## Landscape Referral Response

<b>Application Number:</b>	DA2024/1091
<b>Date:</b>	31/07/2025
<b>Proposed Development:</b>	Demolition works and construction of a mixed use development with basement parking comprising of retail uses and a childcare centre
<b>Responsible Officer:</b>	Claire Ryan
<b>Land to be developed (Address):</b>	<p>Lot 5 S/P 32656 , 5 / 1 Careel Head Road AVALON BEACH NSW 2107</p> <p>Lot 5 S/P 32656 , 5 / 1 Careel Head Road AVALON BEACH NSW 2107</p> <p>Lot B DP 385973 , 3 Careel Head Road AVALON BEACH NSW 2107</p> <p>Lot 3 S/P 32656 , 3 / 1 Careel Head Road AVALON BEACH NSW 2107</p> <p>Lot 3 S/P 32656 , 3 / 1 Careel Head Road AVALON BEACH NSW 2107</p> <p>Lot 7 S/P 32656 , 7 / 1 Careel Head Road AVALON BEACH NSW 2107</p> <p>Lot 7 S/P 32656 , 7 / 1 Careel Head Road AVALON BEACH NSW 2107</p> <p>Lot 1 S/P 32656 , 1 / 1 Careel Head Road AVALON BEACH NSW 2107</p> <p>Lot 1 S/P 32656 , 1 / 1 Careel Head Road AVALON BEACH NSW 2107</p> <p>Lot 4 S/P 32656 , 4 / 1 Careel Head Road AVALON BEACH NSW 2107</p> <p>Lot 4 S/P 32656 , 4 / 1 Careel Head Road AVALON BEACH NSW 2107</p> <p>Lot 6 S/P 32656 , 6 / 1 Careel Head Road AVALON BEACH NSW 2107</p> <p>Lot 6 S/P 32656 , 6 / 1 Ca

Fig.2 Trees 1 and 2 TPZ overlaid to the proposed ground floor level

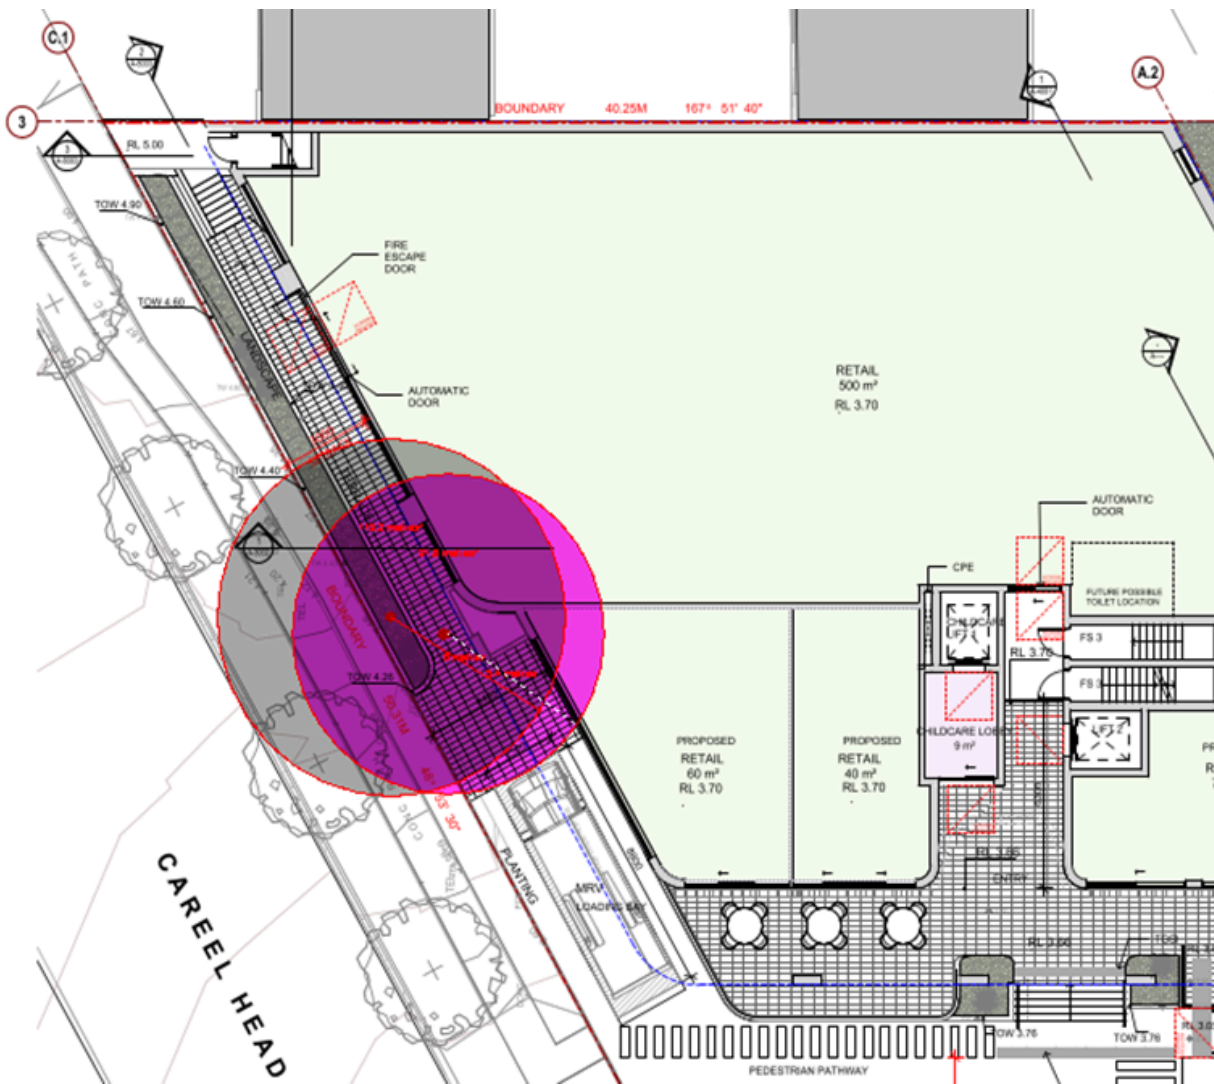
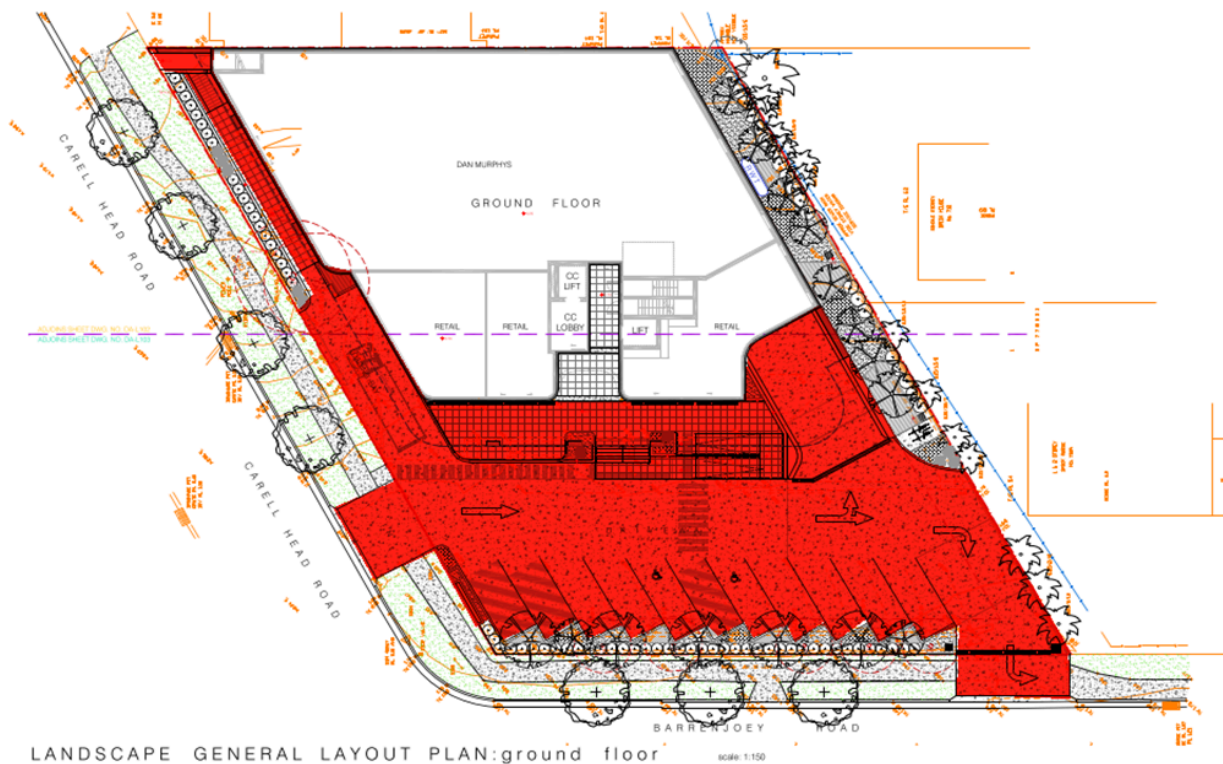
#### 1. Retention of Trees 1 and 2.

Removal of the Norfolk Island Pine and Swamp She Oak are not supported. The trees provide a significant

Given the size of the site, it is considered that the setback required to retain the trees is achievable. Consideration of the planning controls and benefits to the childcare centre indicates that the retention of the trees is desirable. It is considered that the trees should be retained in the re-development of the site.

The plans have been amended to enable retention of the Trees 1 and 2, which is supported.
